July 31, 2016

Re: First Request for Additional Information (RAI)
Pasco County – Solid Waste
Facility Name: Enterprise Road Class III Recycling and Disposal
Facility Site ID: 87895
DEP Application Nos.: 177982-023-SC/T3 and 177982-024-SO/T3

PROJECT NO.:
02000-144-14
SCALE:
AS SHOWN
DATE:
MARCH 2016
DRAWING:
C1.00

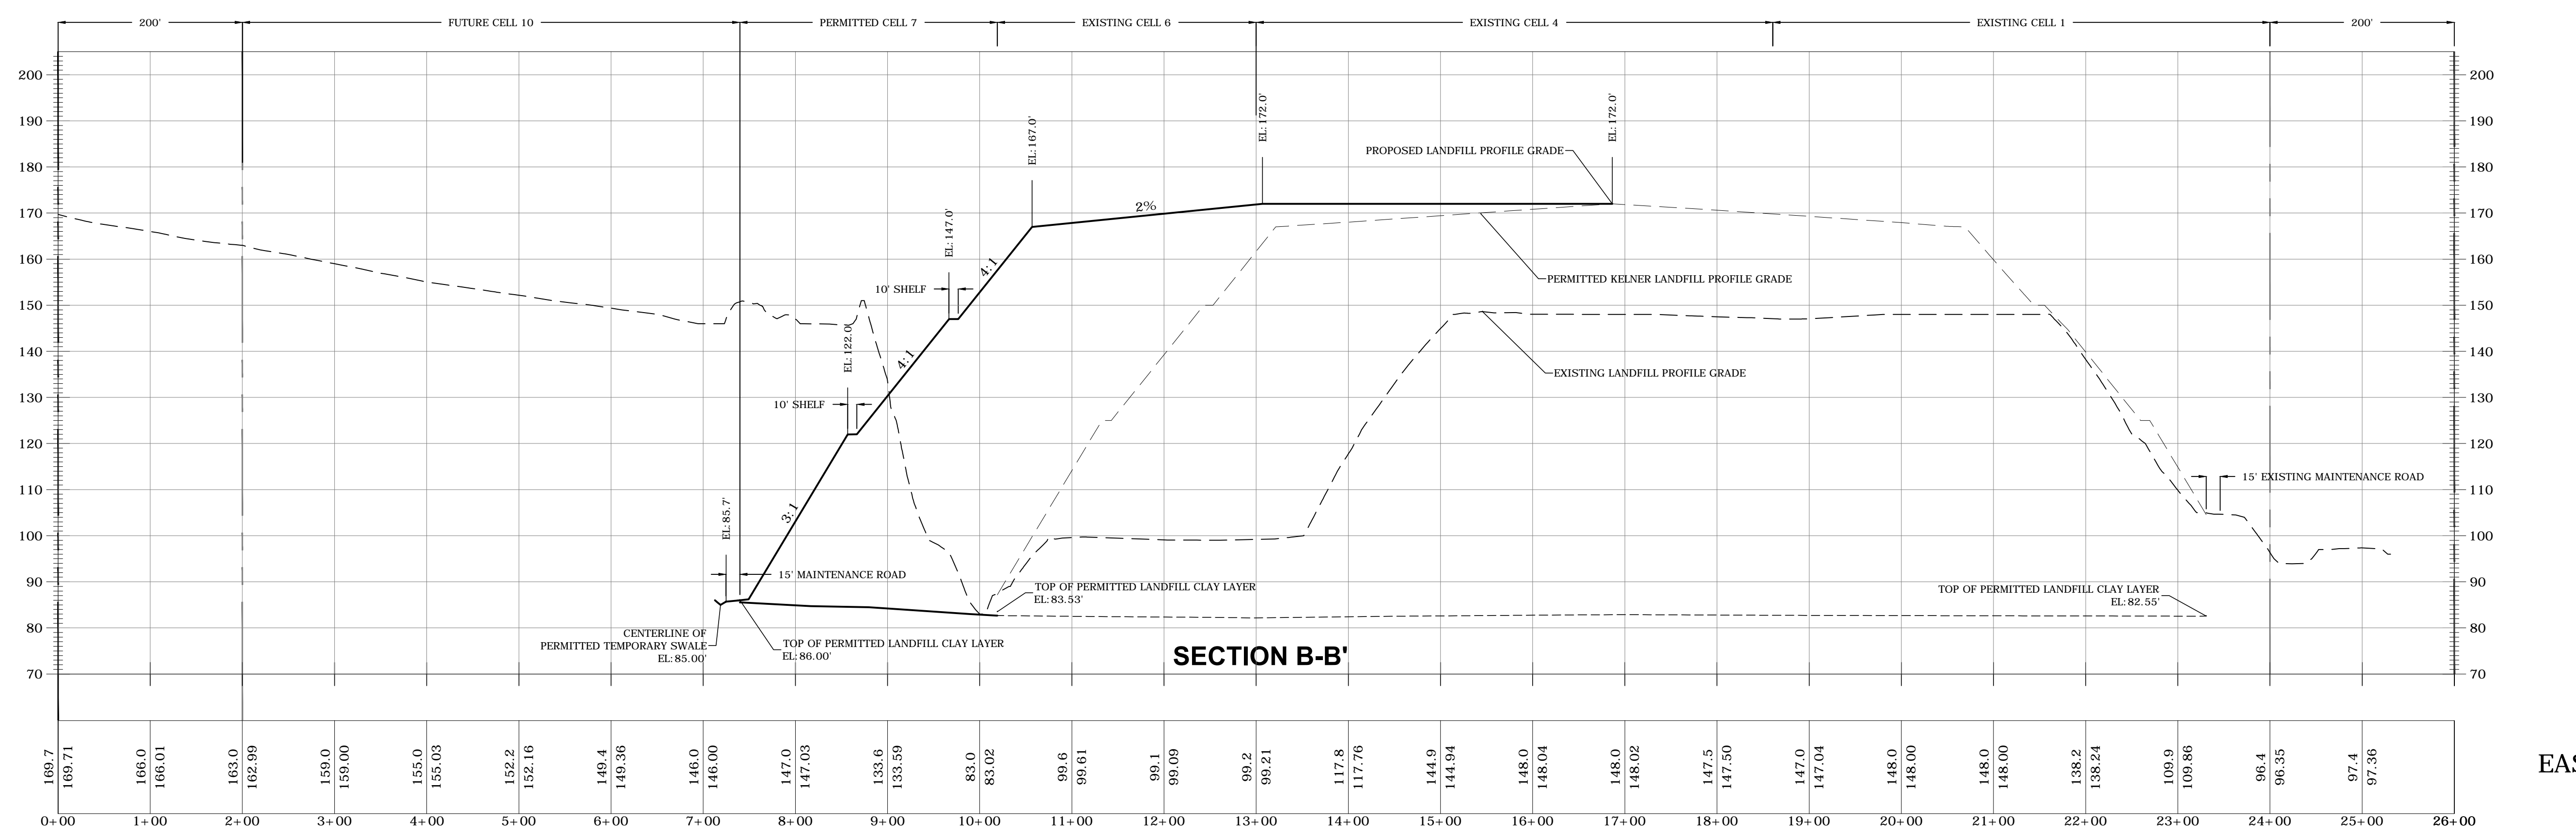
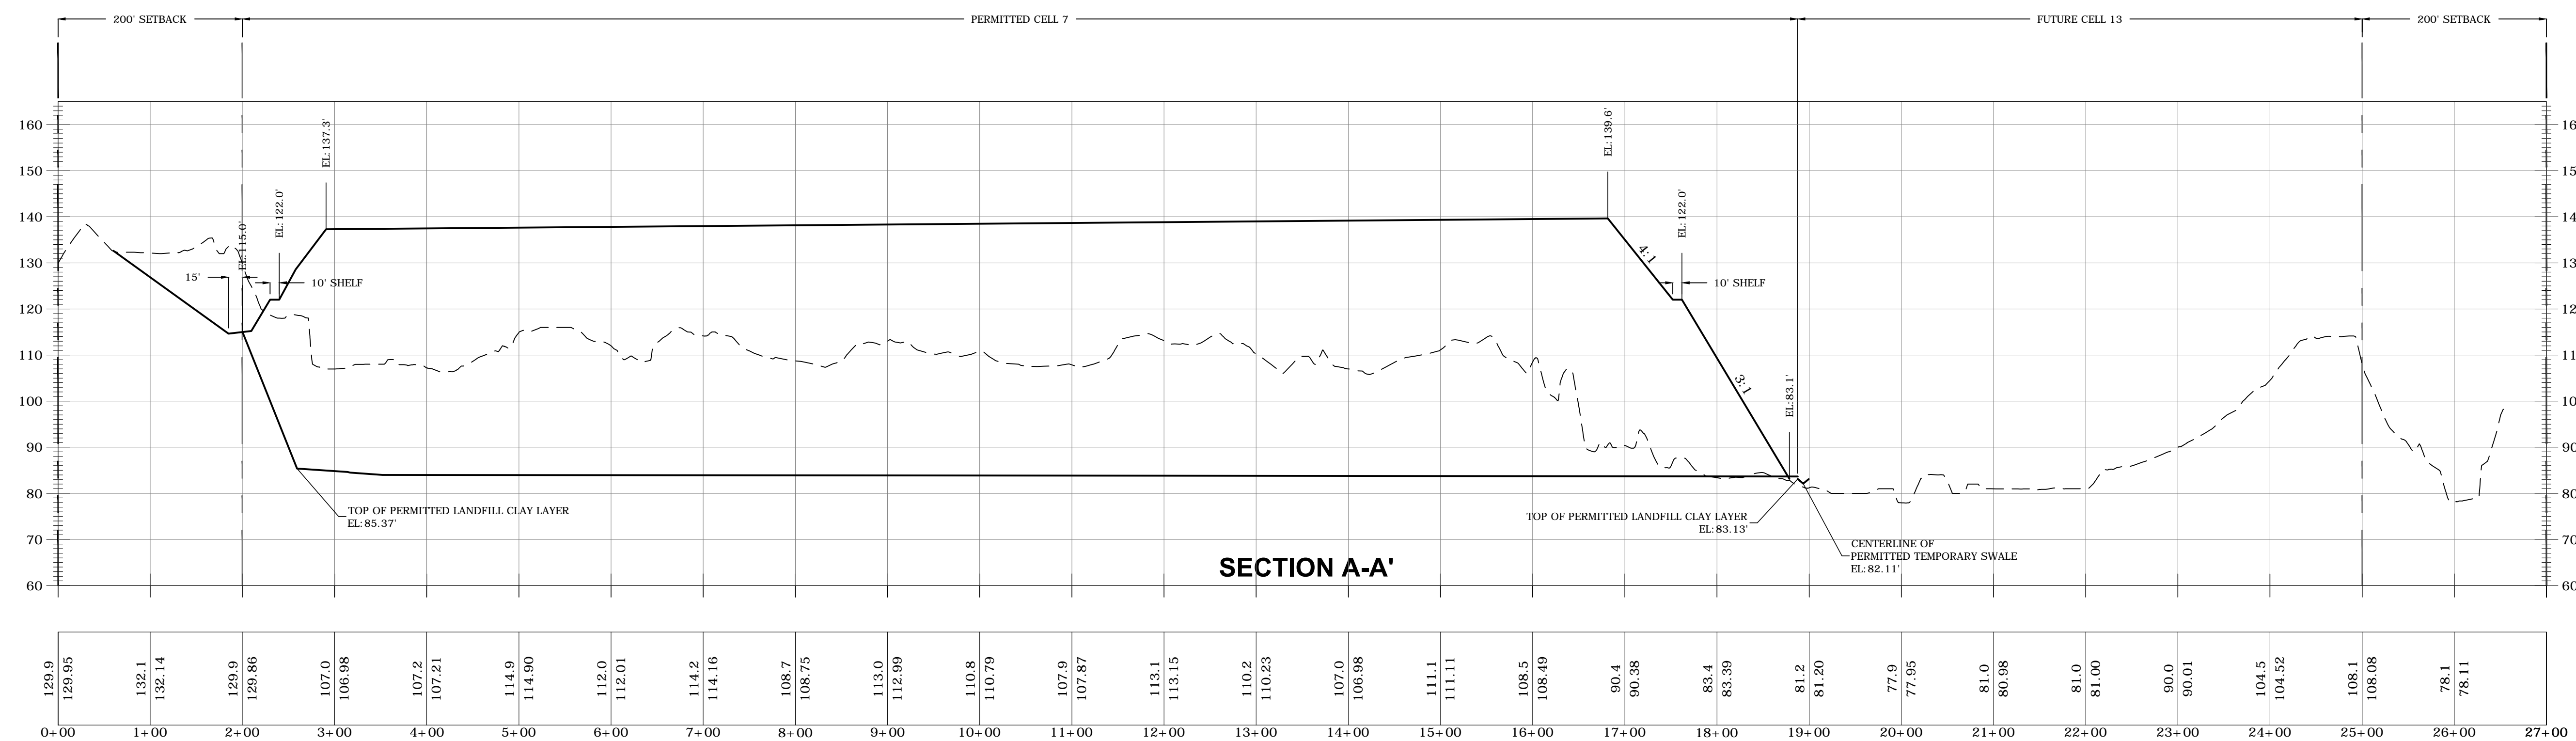
Comment 25: Drawings C1.00: Please verify that the proposed contouring of the south side slope of the temporary stormwater pond to elevation 89' depicted on this sheet will not prevent leachate from draining from the existing disposal cells to the temporary stormwater pond.

PROJECT NO.:	02000-144-14
SCALE:	AS SHOWN
DATE:	MARCH 2016
DRAWING:	C2.00

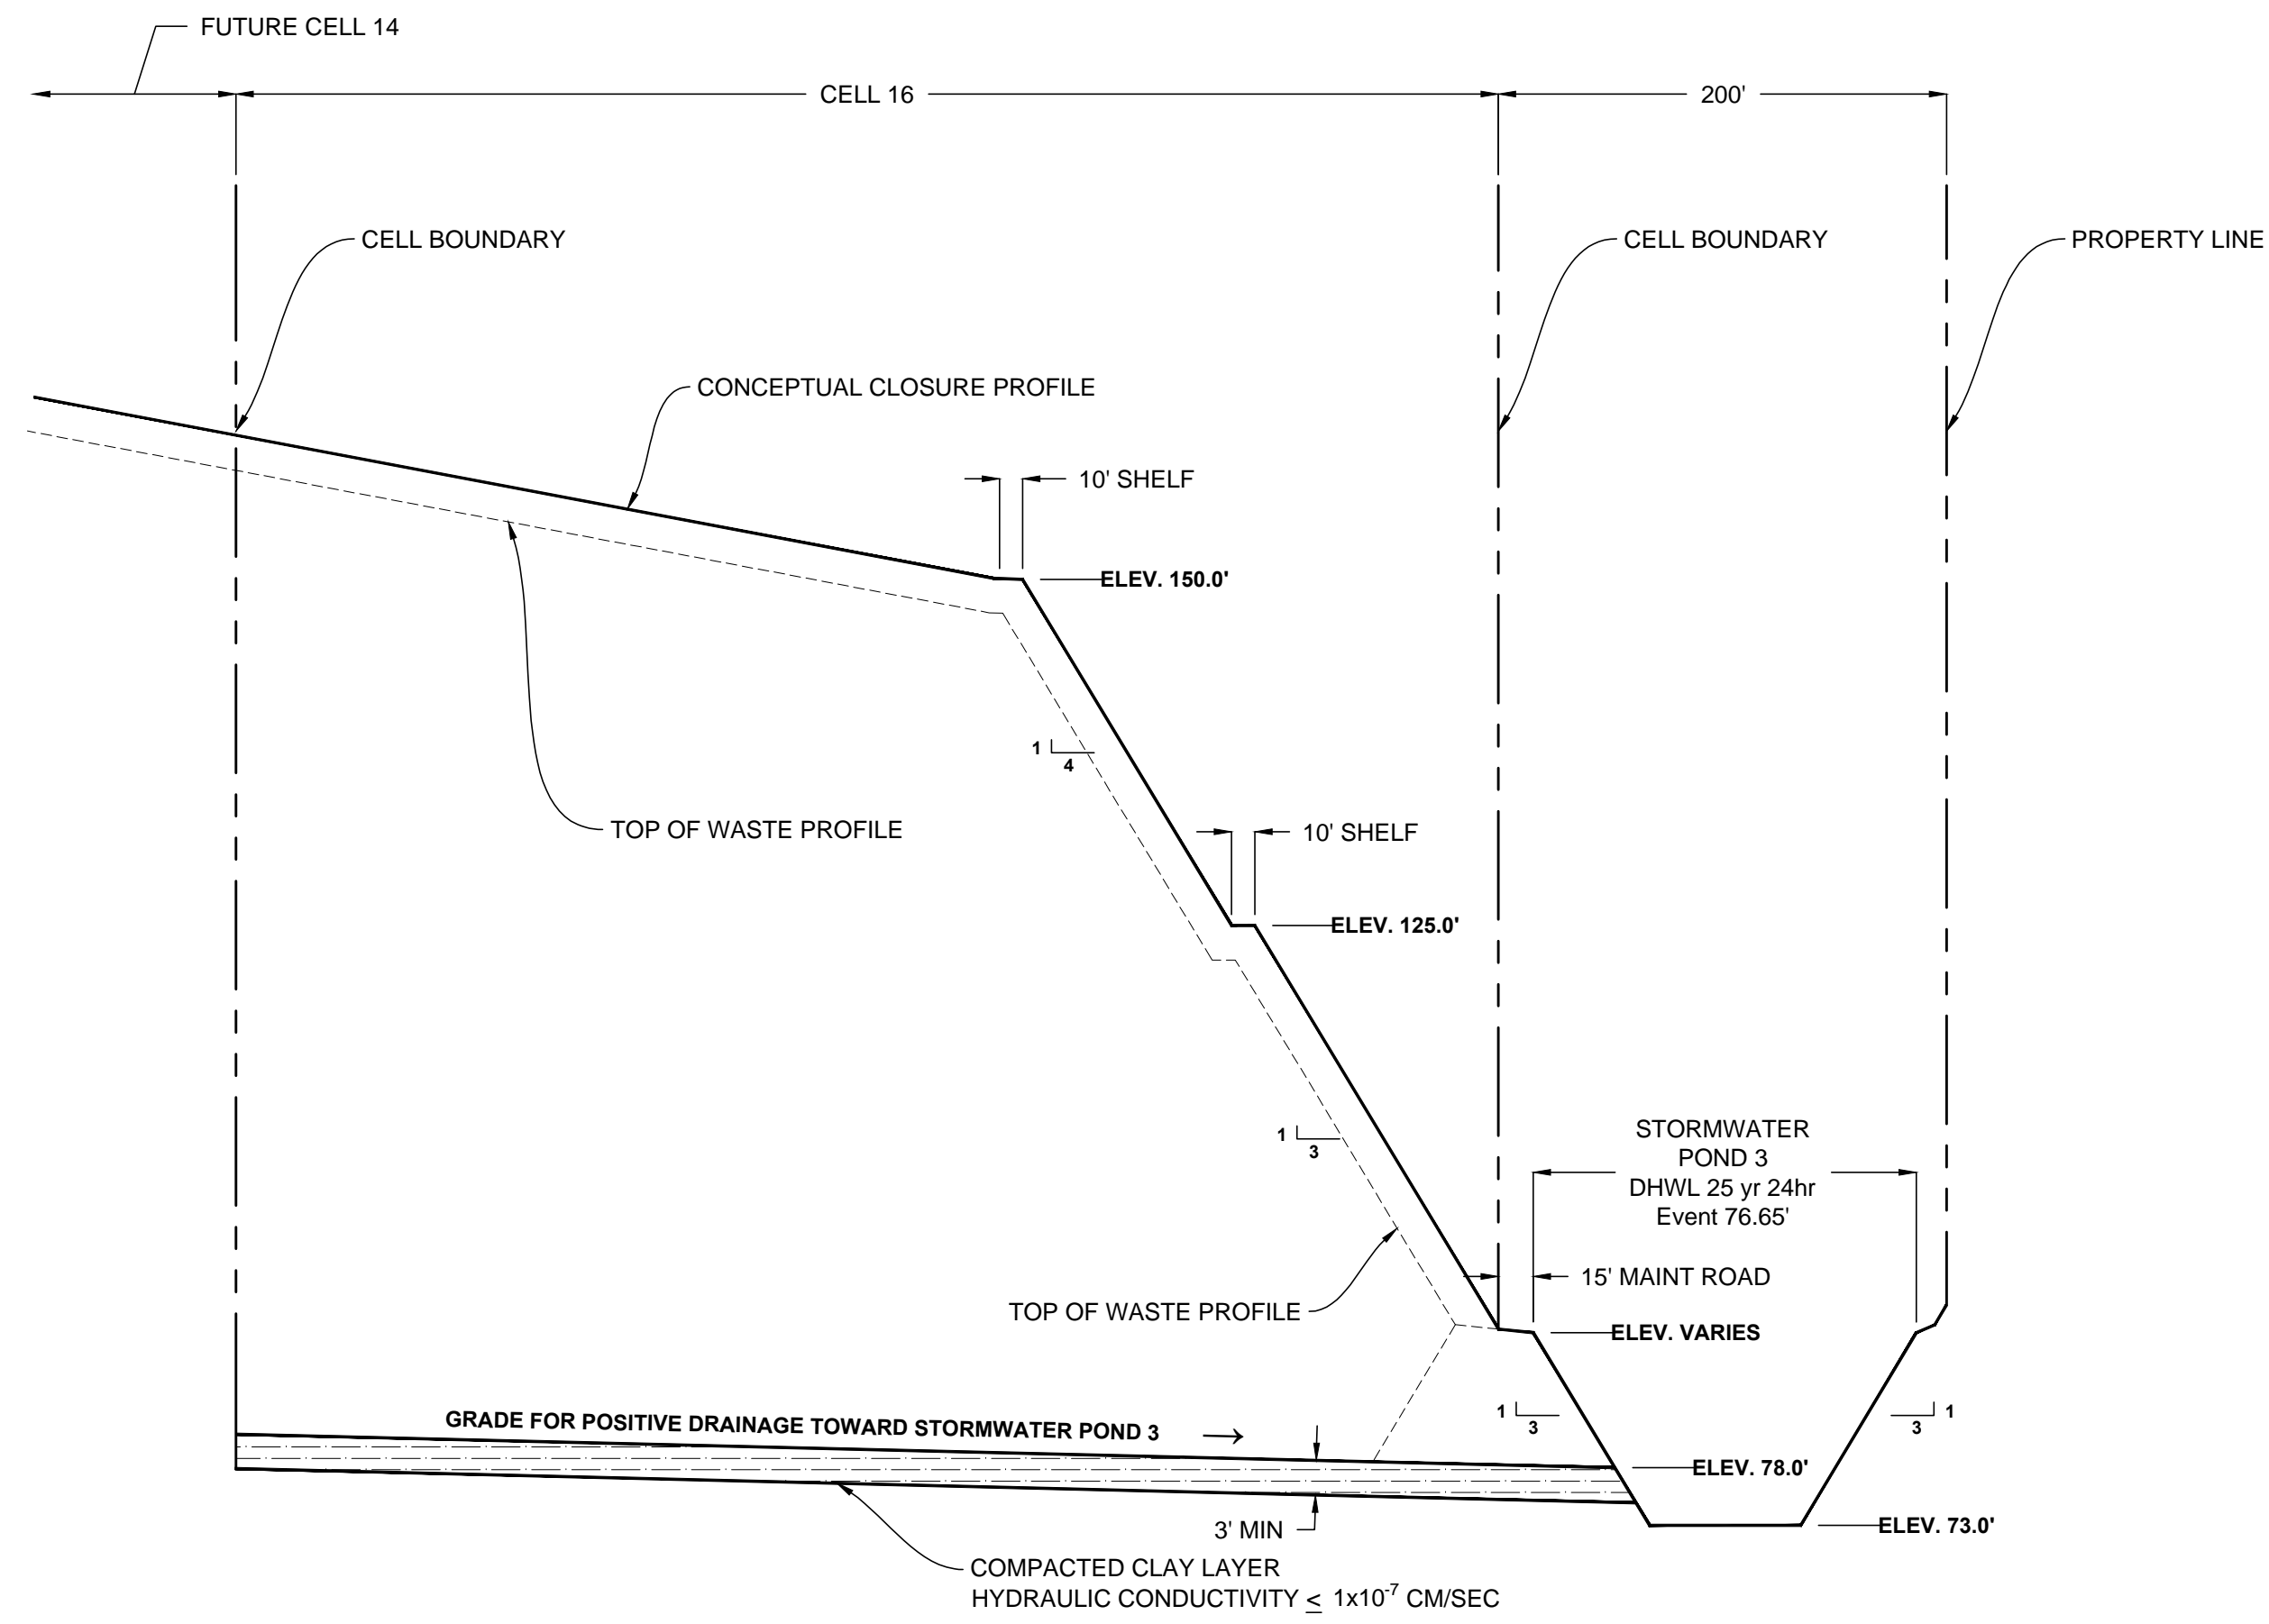
Comment 16: §3.8.1: Please revise this section to clarify that Drawing C2.00 (inclusive of Cell 13-14) is beyond the scope of this application; is provided as a conceptual final buildout closure plan for financial assurance calculations purposes, and that a final closure drawings for Cell 1-7 and 15-16 will be provided in the event that Cells 13 and 14 are not permitted for construction and operation in the future.

Comment 20: §3.10.1.5: Please provide the supporting information, calculations, and or assumptions utilized in support of the proposed location of gas vents shown on Drawing C2.00, concentrated at the highest level of the facility, rather located at roughly equidistant locations throughout the entire footprint of the closed facility, as depicted on Sheet C-8 of the 2012 Kelner Engineering Plan Set.

Comment 26: Drawing C2.00: Conceptual Closure Berm: The current stormwater management side slope conveyance system design includes closure berms and drop inlet at each side slope bench (i.e. elevations 125' and 150') and not at elevation 170'. Please verify and provide a revised detail, similar to the current detail provided on Drawing C-15 (see Permit Modification Nos. 117982-021-SC/IM & 177982-022-SO/MM)

RESPONSE 16: Drawing C2.00 has been revised and no longer includes Cells 13 and 14.

RESPONSE 20: Section 3.10.1.5 and Drawing C2.00 have been revised to reflect the gas vent spacing shown on sheet C8 of the 2012 Kelner Engineering Plan Set.

RESPONSE 26: Drawing C2.00 has been revised to remove the drop inlets previously shown on the top deck as well as updating the referenced detail.
